Process Change Notice

5.0 watt silicon Zener diodes packaged in the AX-5W axial leaded epoxy case.

Devices that are presently packaged in the AX-5W case are being manufactured in the DO-201 case.

Figure 1: Mechanical Outline of Obsolete AX-5W Case

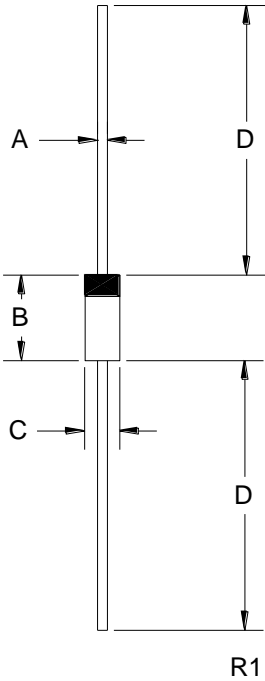
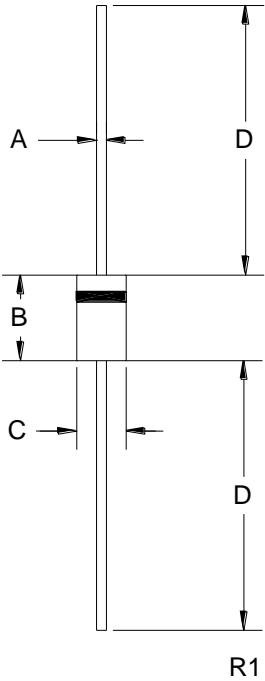
The AX-5W case has been discontinued due to lack of interest and replaced with the DO-201 case.

- Electrical Performance
 - No change
- Physical Dimensions
 - No change in lead diameter
 - No change in lead length
 - Small change in body length, (see Figures 1 and 2 – dimension B)
 - Small change in body width, (see Figures 1 and 2 – dimension C)

Figure 2: Mechanical Outline of Replacement DO-201 Case
